**State of Alaska
Department of Fish and Game
Sportfish Division**

**Nomination Form
Anadromous Waters Catalog**

Nomination #	<u>25-684</u>		<u>9/24/2025</u>
		Fisheries Scientist	Date
Revision Year:	<u>2026</u>		<u>9/24/25</u>
		Habitat Operations Manager	Date
Revision to:	<input checked="" type="checkbox"/> Atlas <input checked="" type="checkbox"/> Catalog		<u>18 Sept 2025</u>
		AWC Project Biologist	Date
Revision Code:	<u>C-9, C-1, A-1, A-3</u>	<u>P.A.</u>	<u>9/30/2025</u>
		GIS Analyst	Date

Perm # 25-684

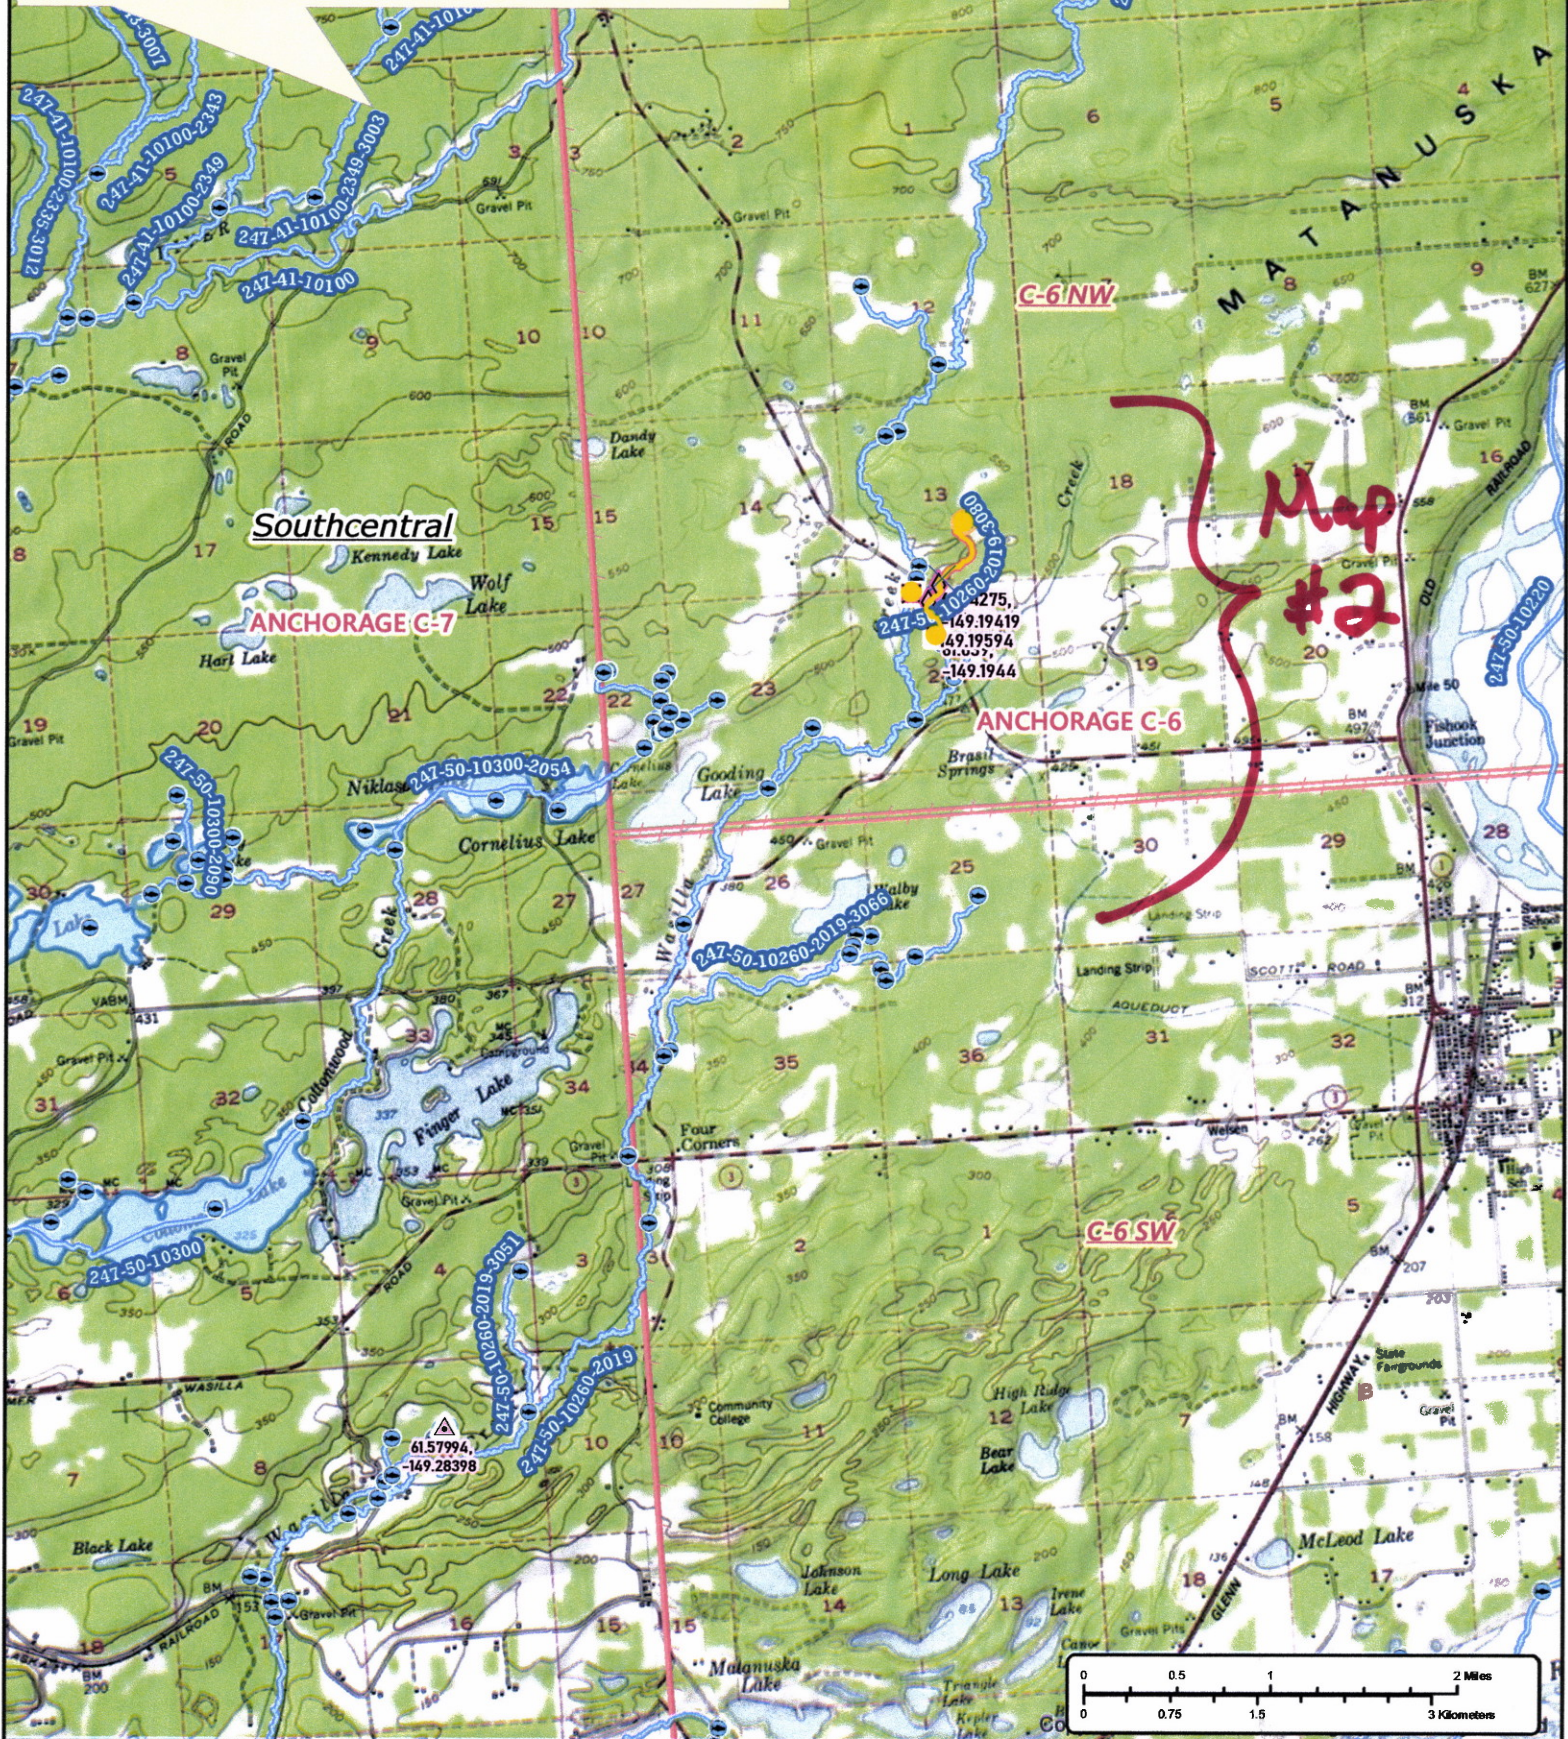
-UPDATE/ADJUST hydrography to connect upper end of existing AWC Stream #247-50-10260-2019-3076-4050 with the upper portion of existing AWC Stream #247-50-10260-2019-3080.

-RENUMBER upper portion of existing AWC Stream #247-50-10260-2019-3080 to existing AWC Stream #247-50-10260-2019-3076-4050.

-REMOVE lower portion of remaining section of existing AWC Stream #247-50-10260-2019-3080.

+ Please update using most recent GDB with line, point, lake, polygon and barrier features located in O:\DSFR5\AWC\Draft2026\GISData\AWC2026_VrkingV1_7April2026.gdb

Map #1

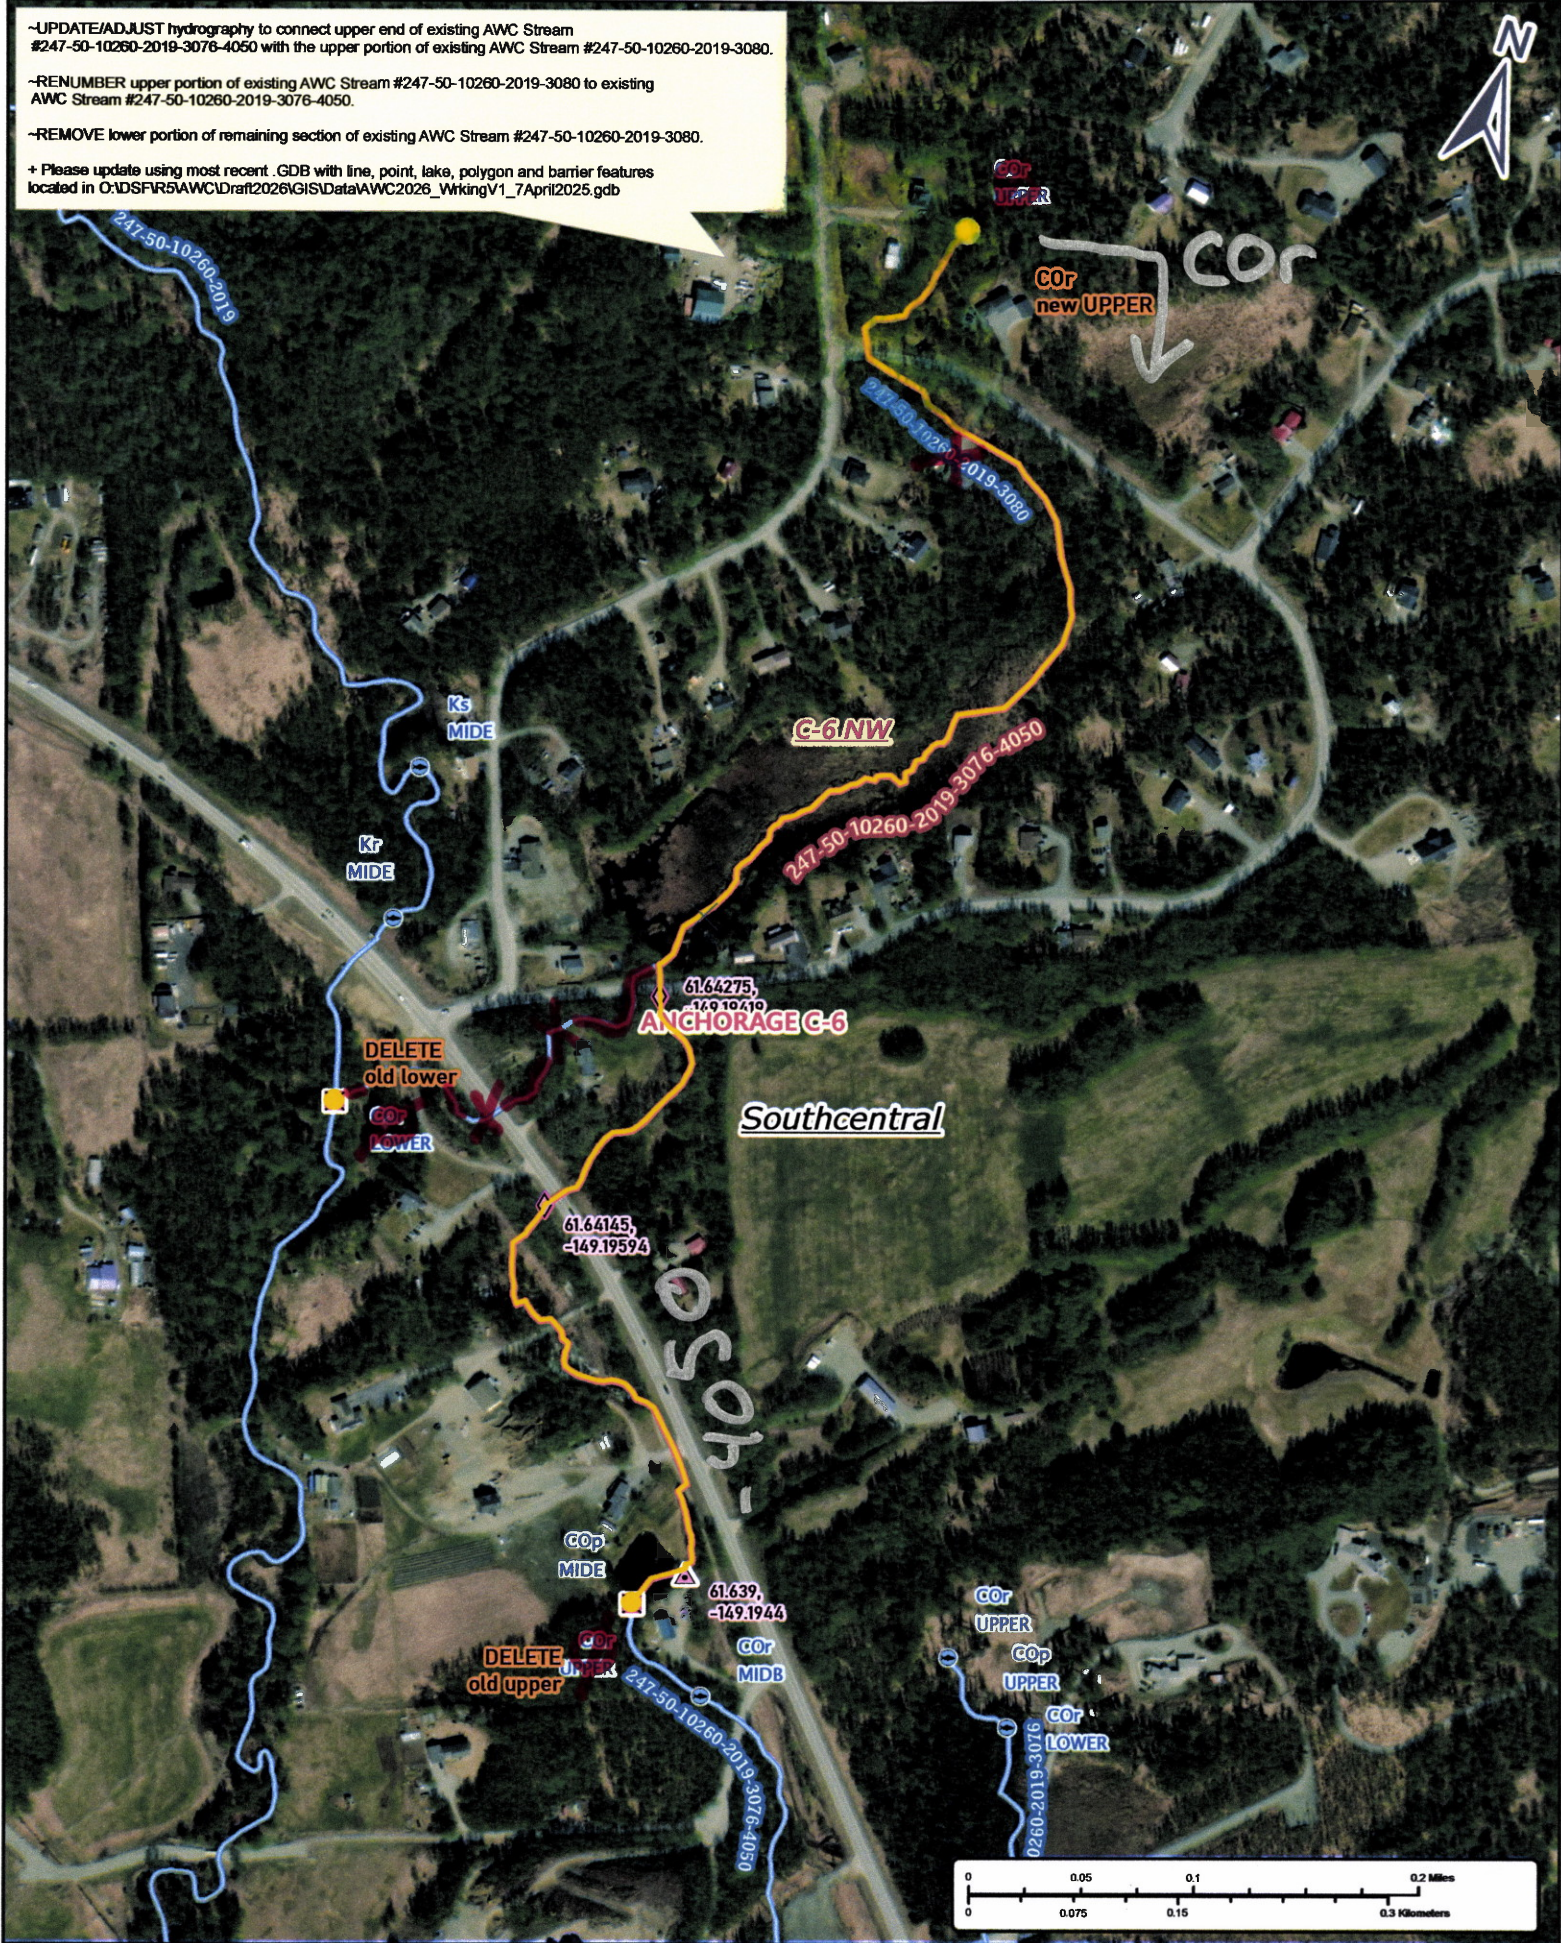
-UPDATE/ADJUST hydrography to connect upper end of existing AWC Stream #247-50-10260-2019-3076-4050 with the upper portion of existing AWC Stream #247-50-10260-2019-3080.

-RENUMBER upper portion of existing AWC Stream #247-50-10260-2019-3080 to existing AWC Stream #247-50-10260-2019-3076-4050.

-REMOVE lower portion of remaining section of existing AWC Stream #247-50-10260-2019-3080.

+ Please update using most recent .GDB with line, point, lake, polygon and barrier features located in O:\DS\FR5\AWC\Draft2026\GIS\Data\AWC2026_WrkingV1_7April2025.gdb
